**ASCE 41-17 Tier 1 Seismic Evaluation**

Building Name: American Baptist Seminary, Karpe Hall

Address: 2521 Hillegass Avenue, Berkeley, CA 94704

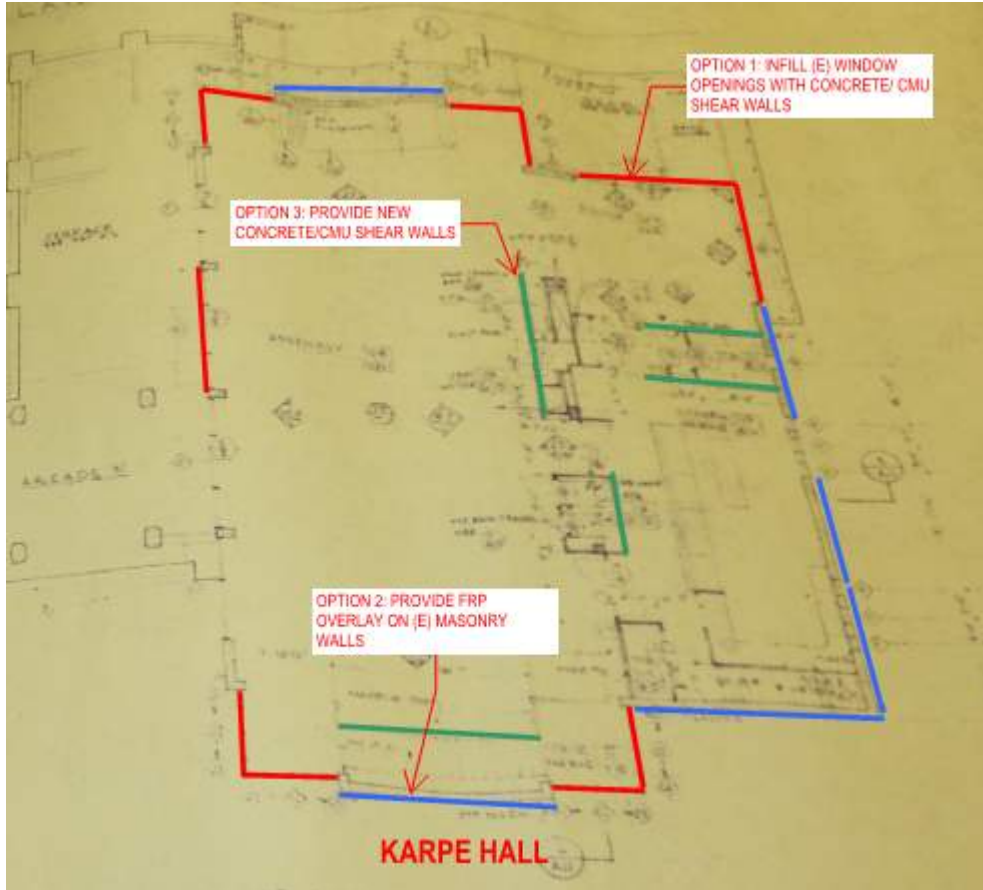
1. *Lateral System Stress Check:* Exterior shear walls are deficient in shear capacity primarily due to the large number of window openings in the building. The shear walls may develop large shear cracks during a lateral event due to lack of shear capacity.

2. *Adjacent Buildings:* Karpe Hall is connected to the Academic Building via a two story, covered walkway. The walkway roof almost aligns with the Roof of Karpe Hall and Second Floor of Academic Building. Due to a small joint, pounding is expected between the walkway roof and Academic Building in the north-south direction, but minimal structural damage is anticipated since the floor levels almost align. Although there is a structural separation between the walkway roof and Karpe Hall, in the east-west direction, the canopy roof is 'locked' into the door cavity of the Academic Building. The Academic Building is structurally stiffer than the walkway cantilever columns, and will resist movement of the walkway roof, but the far side of the roof (near Karpe Hall) is free to move. This will cause significant torsion in the walkway roof and increased demands and damage to the cantilevered columns. Some cracks may appear in the roof slab and columns due to unequal load distribution due to torsion.

3. *Openings at Shear Walls:* A large diaphragm opening along the west shear wall occurs at the First Floor. Cracking around the opening corners may occur during an earthquake due to stress concentration. Existing drawings of the building are not available to understand if the floor was detailed adequately with reinforcing around this opening to prevent cracking and have an adequate diaphragm force transfer around the opening.

4. *Masonry or Concrete Wall Anchorage at Flexible Diaphragm:* The out of plane anchorage of the two story masonry wall above the stair opening at the First Floor is inadequate, and the diaphragm may pull away from the wall in case of a seismic event and may cause a partial collapse of the roof.

*Preliminary proposed retrofit schemes*

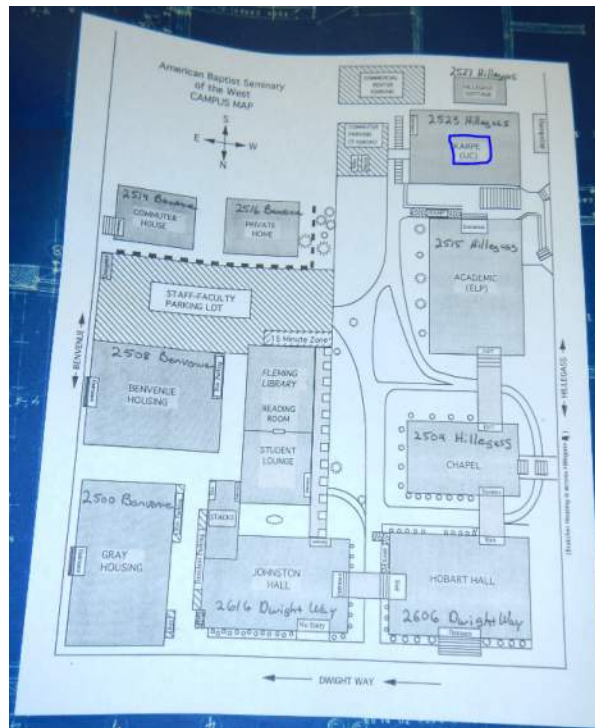
In order to increase the shear capacity of the shear walls some of the window openings can be infilled with concrete or masonry, additional interior masonry walls can be built, or Fiber Reinforced Polymer (FRP) overlay can be applied to existing walls to increase shear capacity.
